Liberty School District – LED Lighting Upgrades
Addendum No: 001
Description Narrative
September 5, 2023

**Liberty North High School Lighting Upgrades
Smith & Boucher Project No. 2314711**

**Liberty Discovery Middle School Lighting Upgrades
Smith & Boucher Project No. 2314702**

E101B

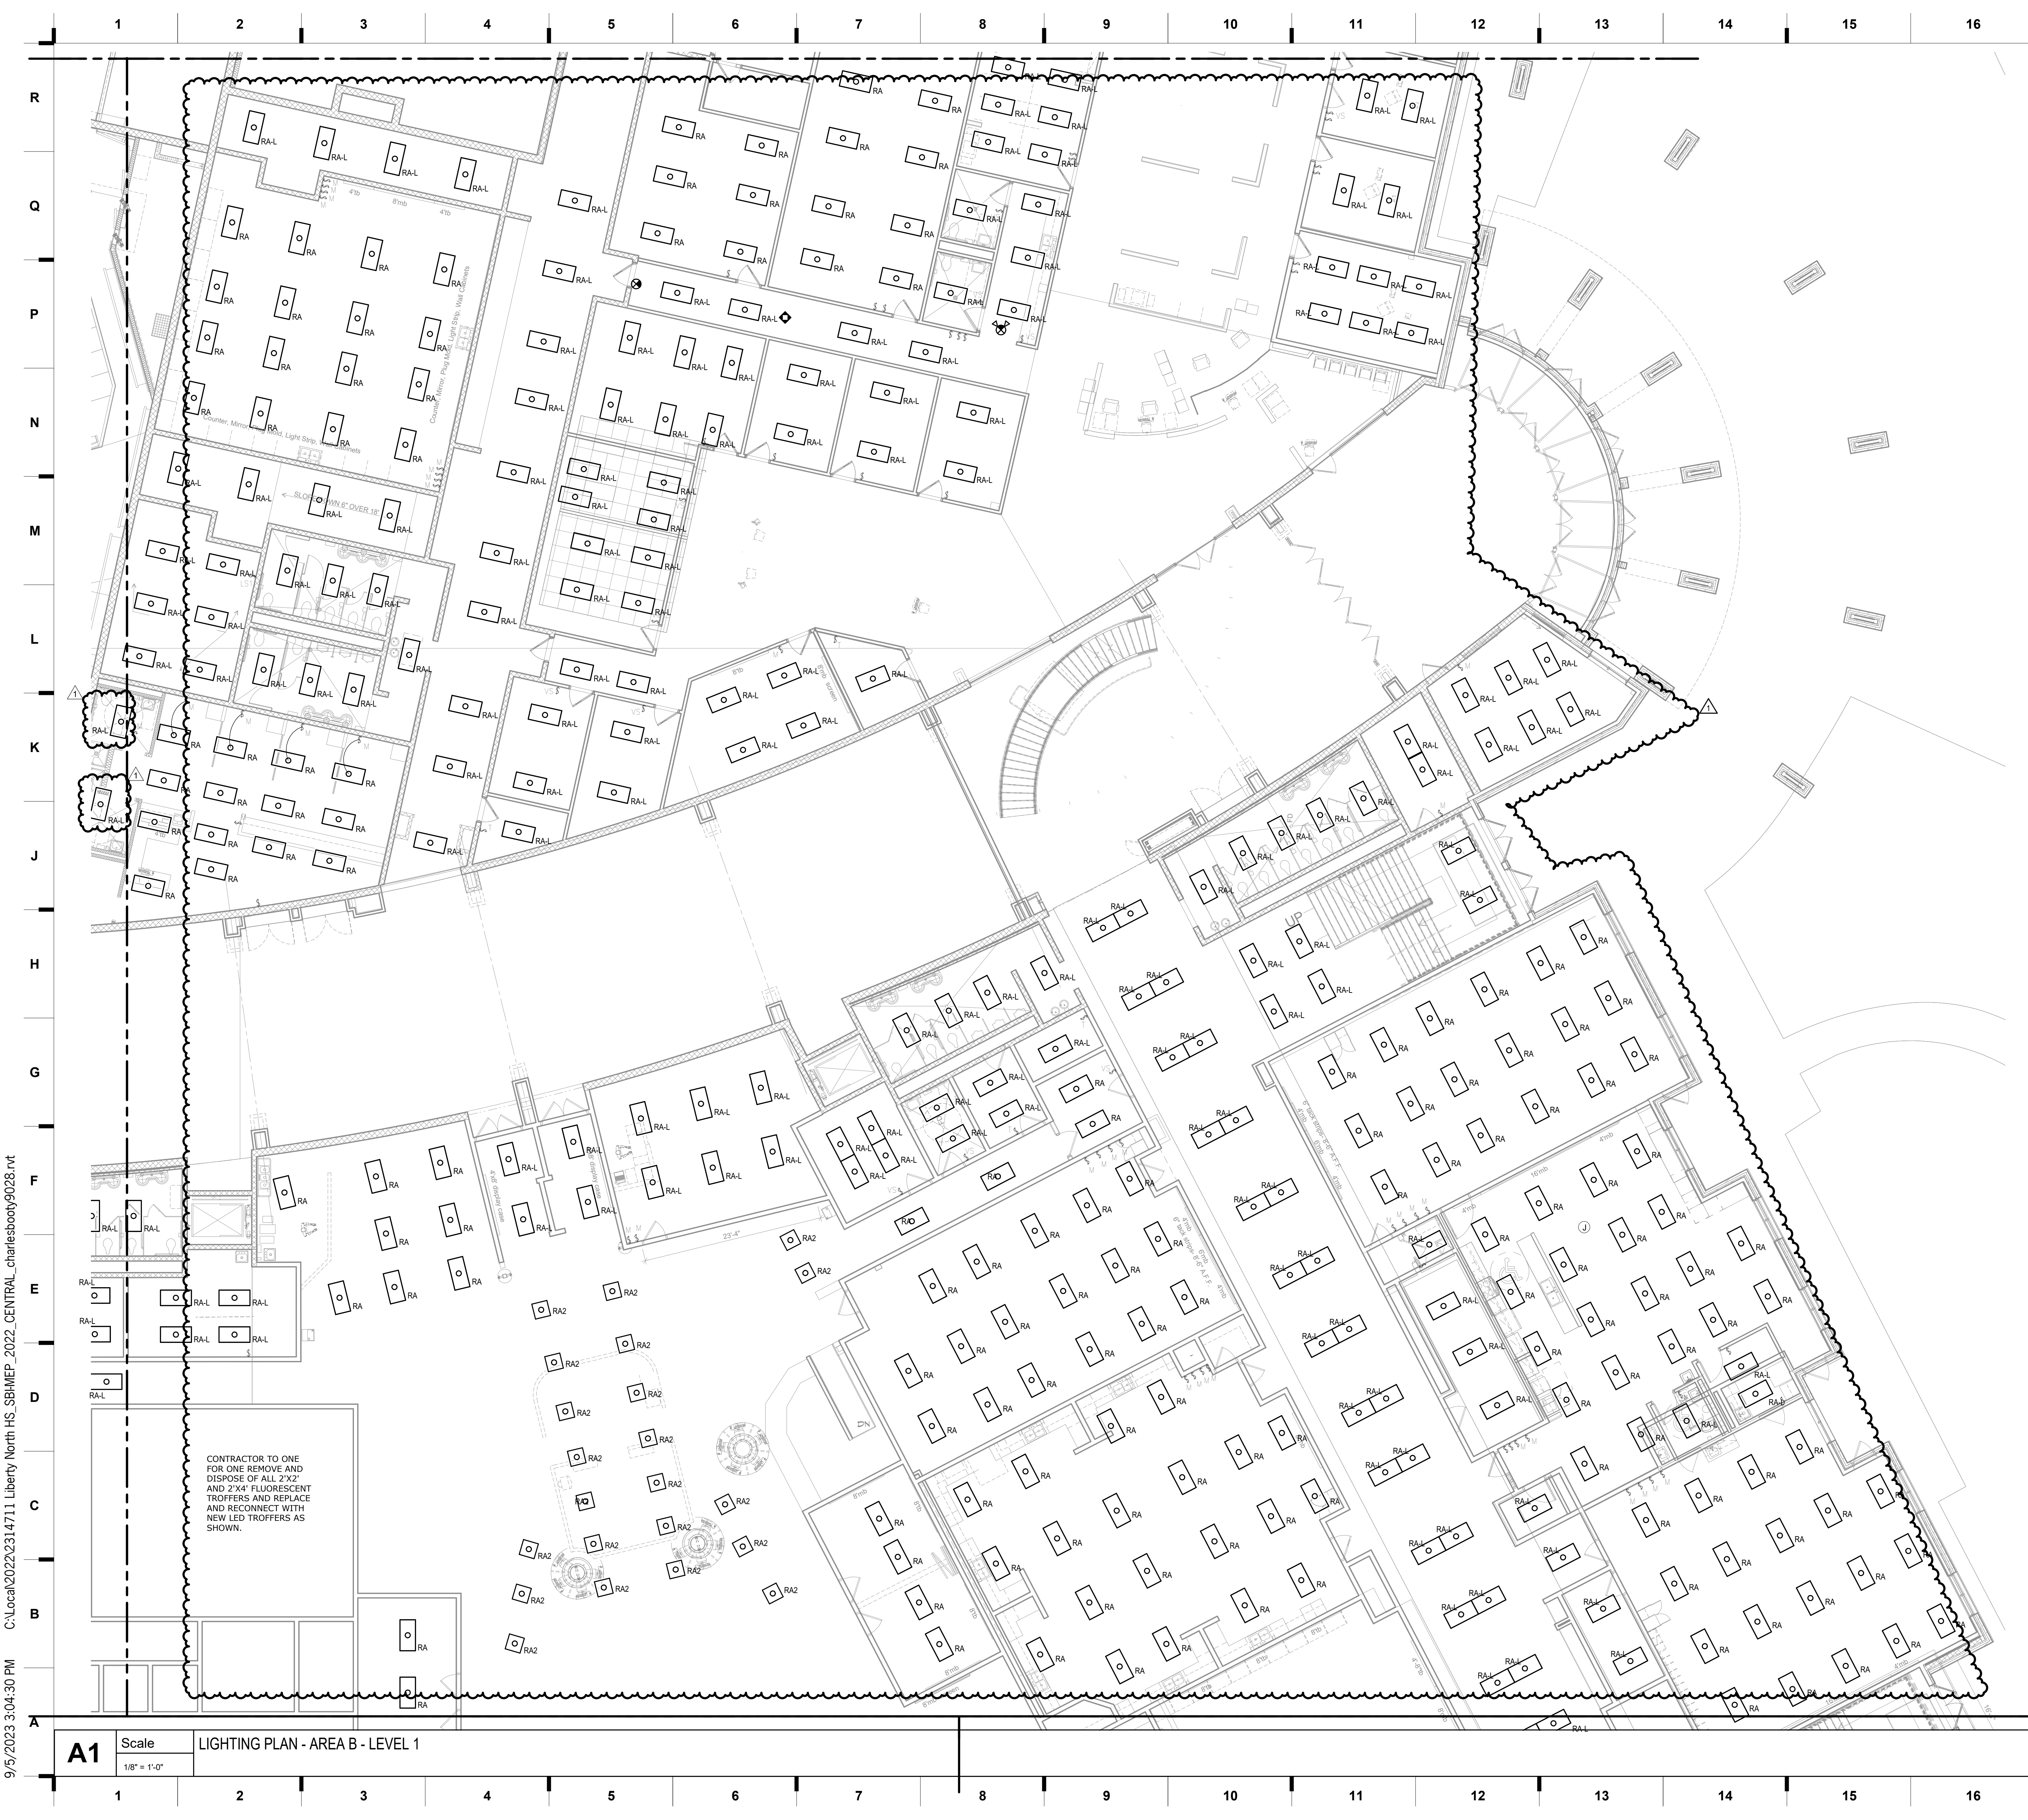
3. Sheet E101B-MAIN LEVEL – AREA B
 - a. Revised corridor troffers and troffers in small rooms to be RA-L indicating that the flat panel troffer to be set on the lowest output level.

E101D

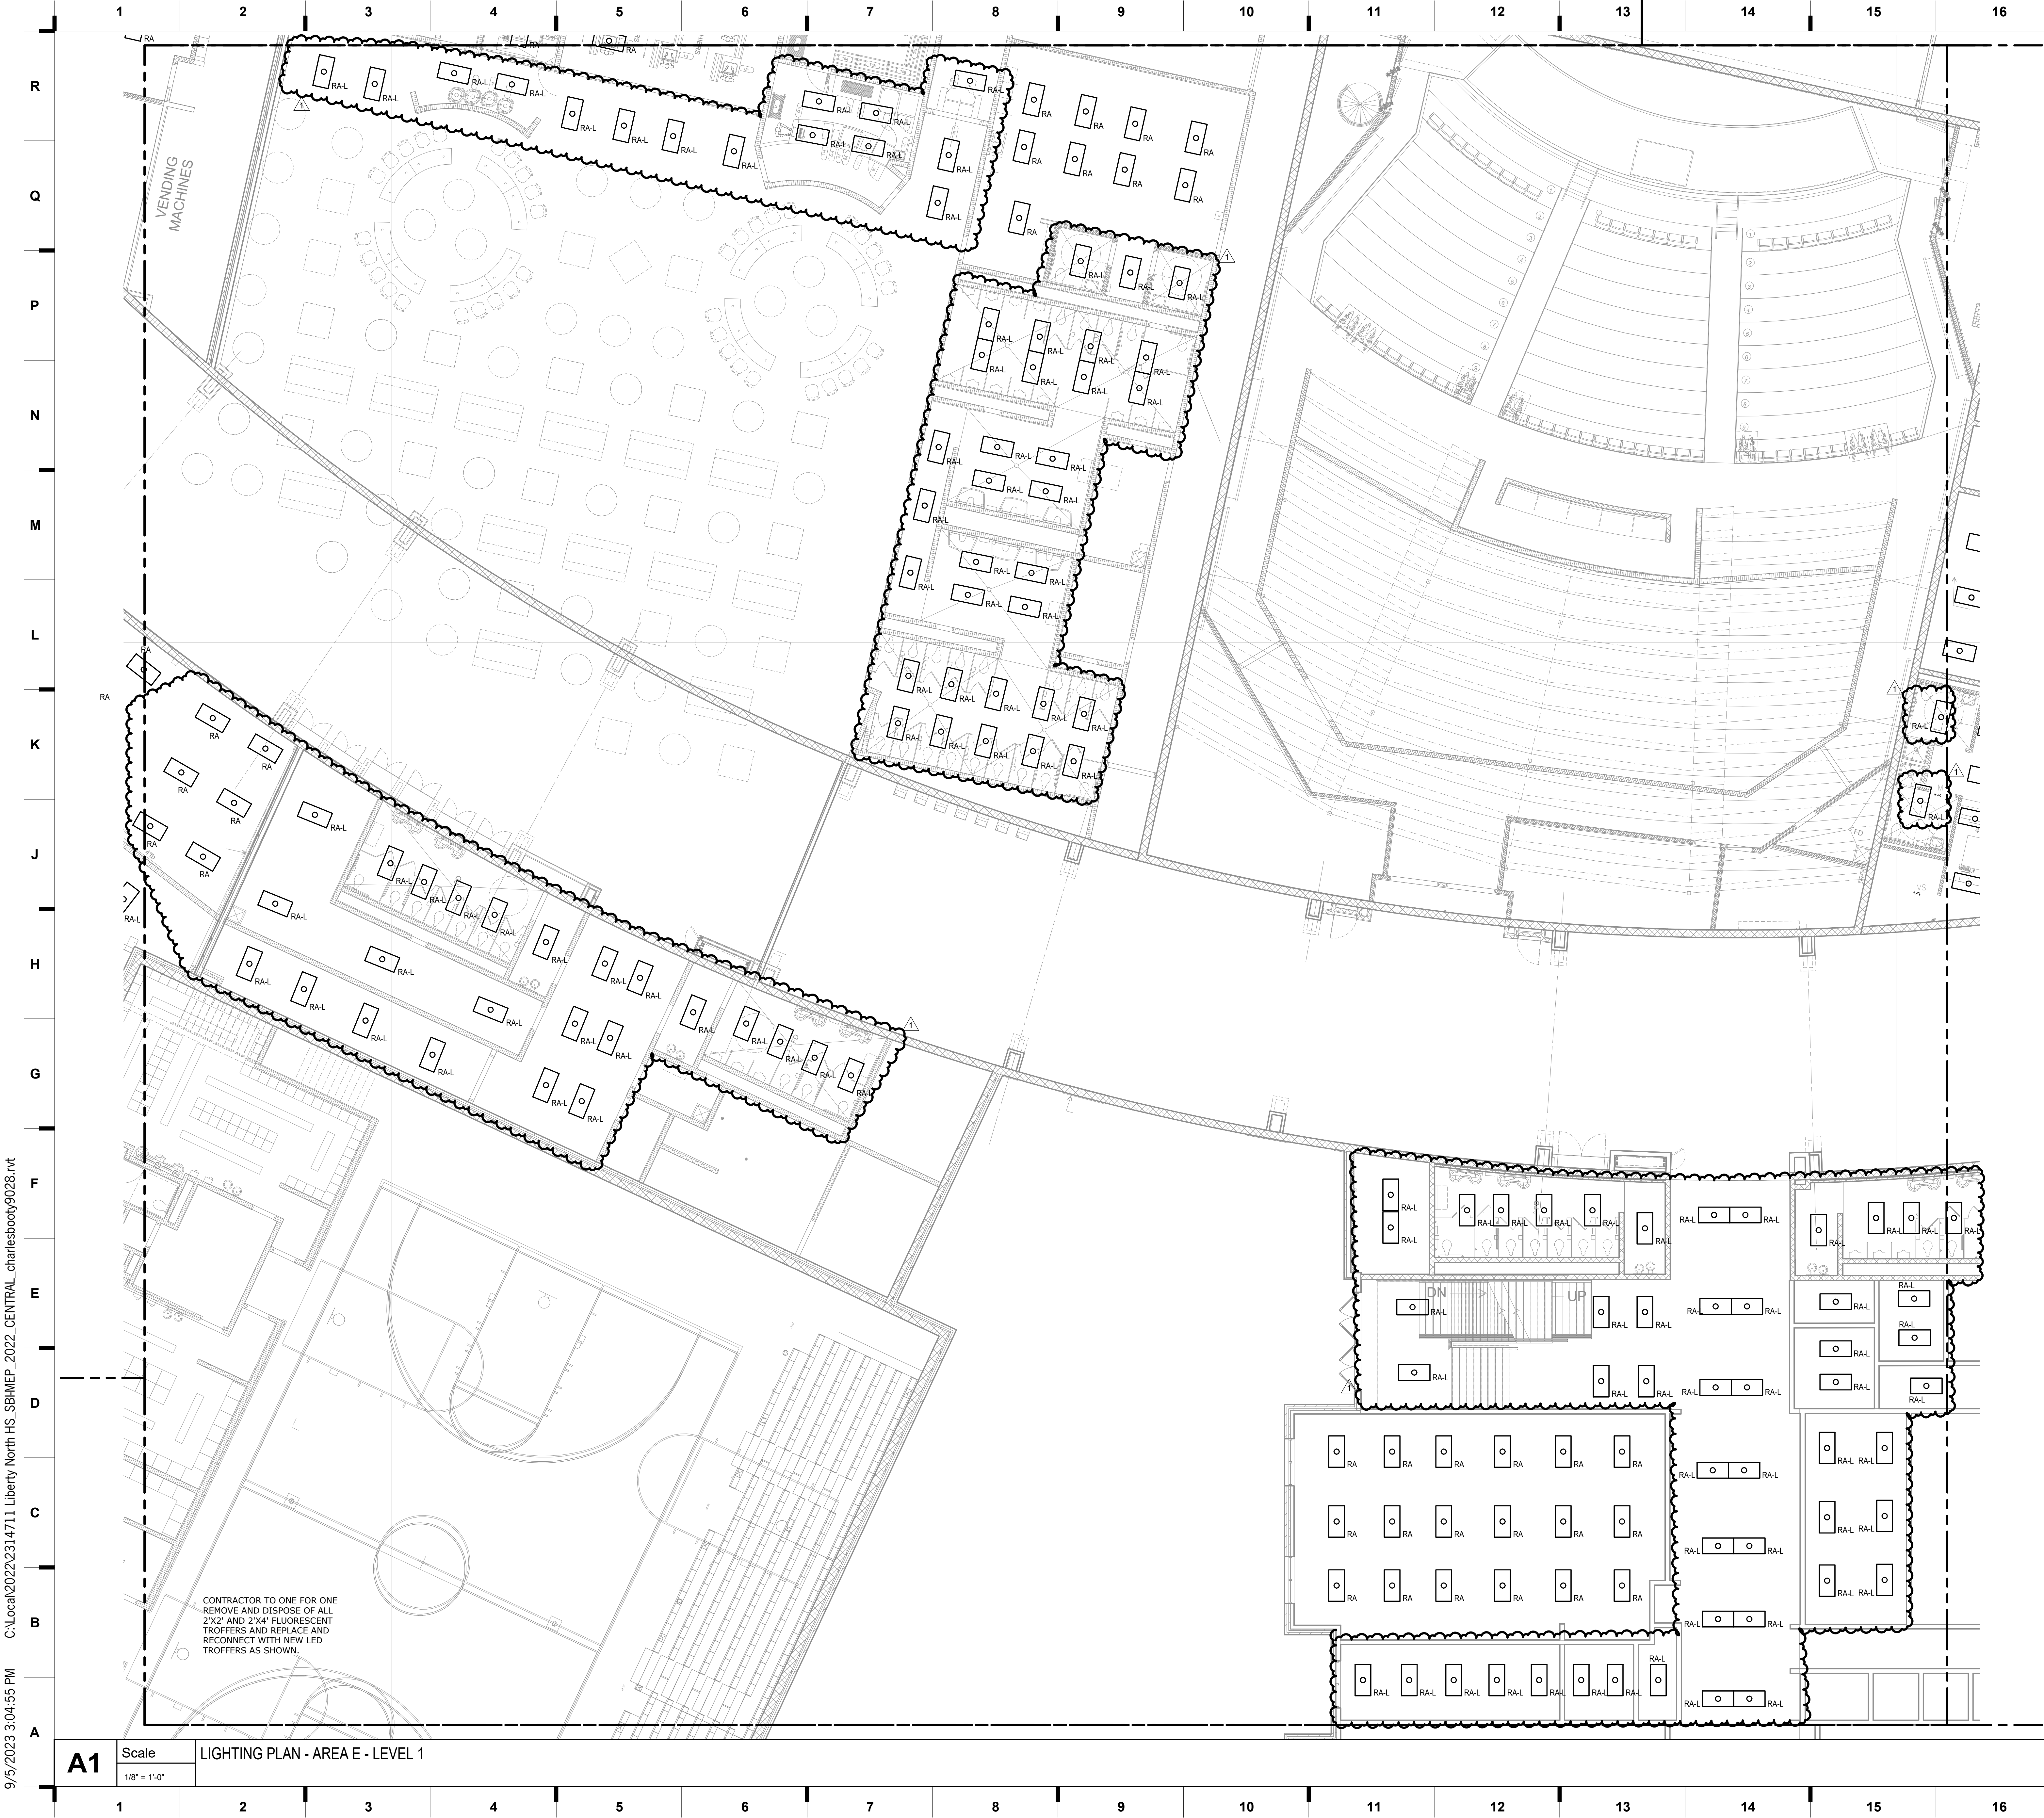
5. Sheet E101D-MAIN LEVEL – AREA D
 - a. Revised corridor troffers and troffers in small rooms to be RA-L indicating that the flat panel troffer to be set on the lowest output level.

- b. Added in missing section of classrooms and corridor that was cut off by top of drawing, added it off to the side.
6. Sheet E101E-MAIN LEVEL – AREA E

E101G

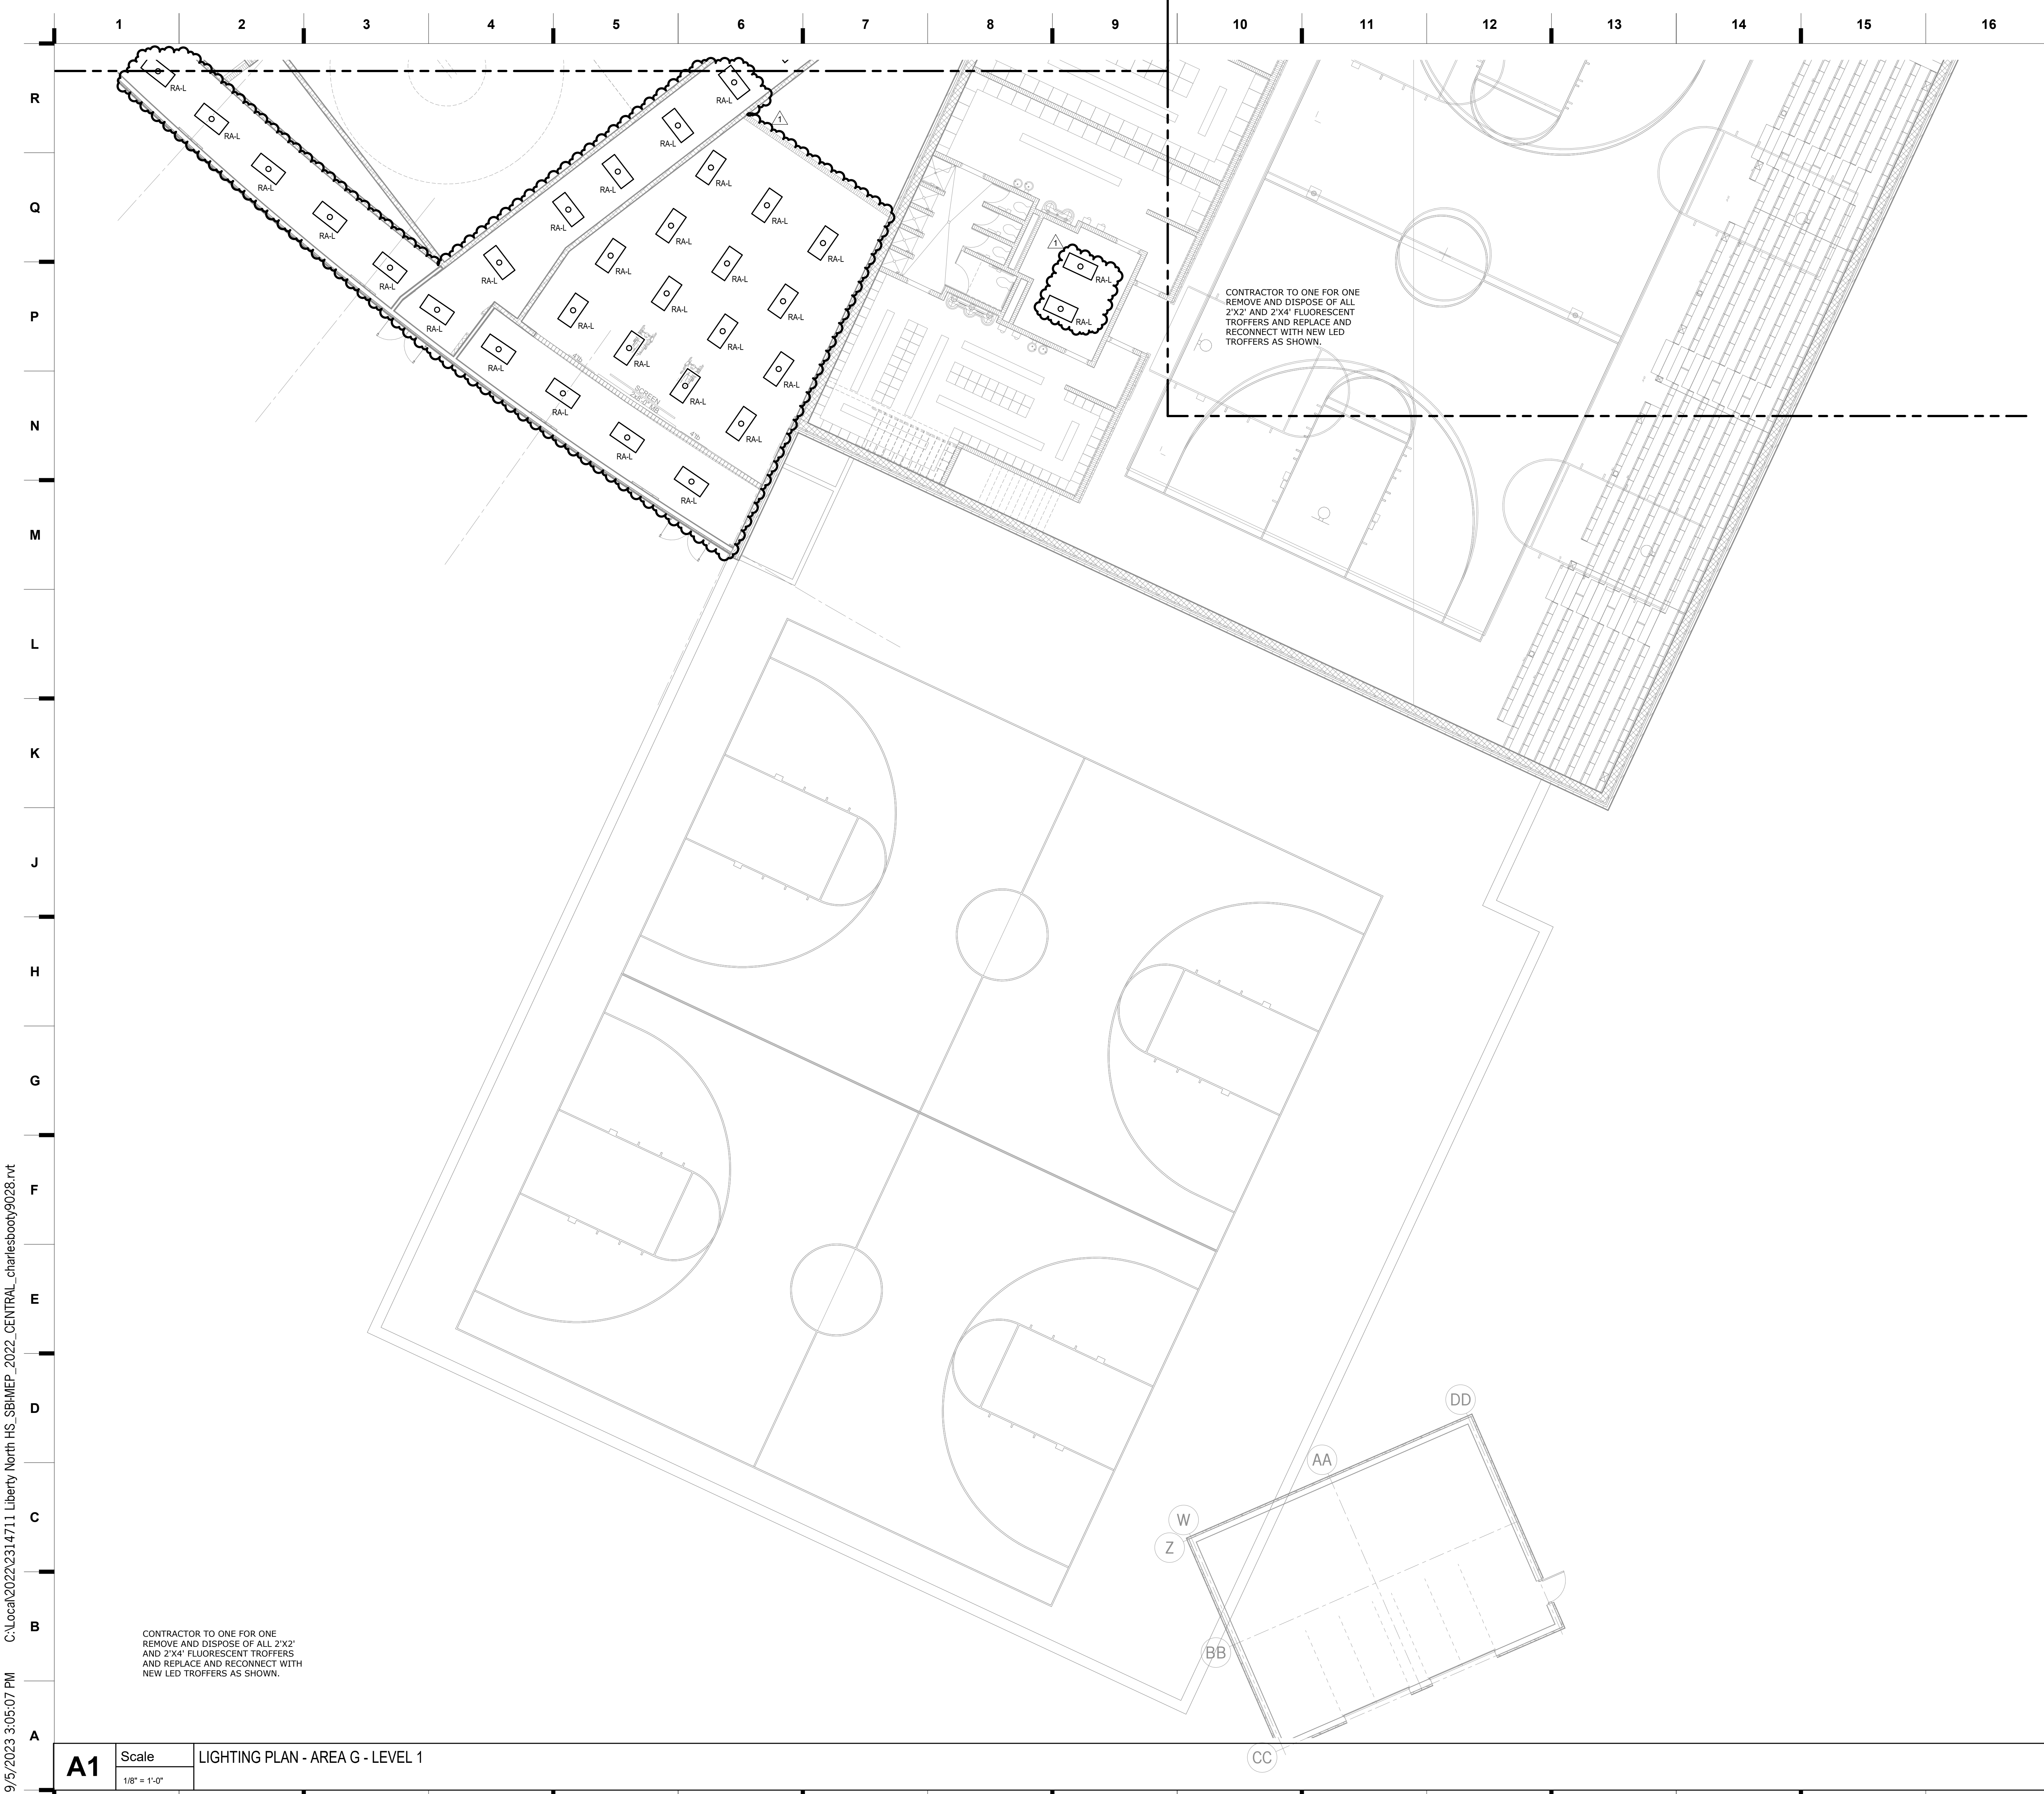
- a. Revised corridor troffers and troffers in small rooms to be RA-L indicating that the flat panel troffer to be set on the lowest output level.
 - b. Added in missing troffers in corridors and classroom and storage room.
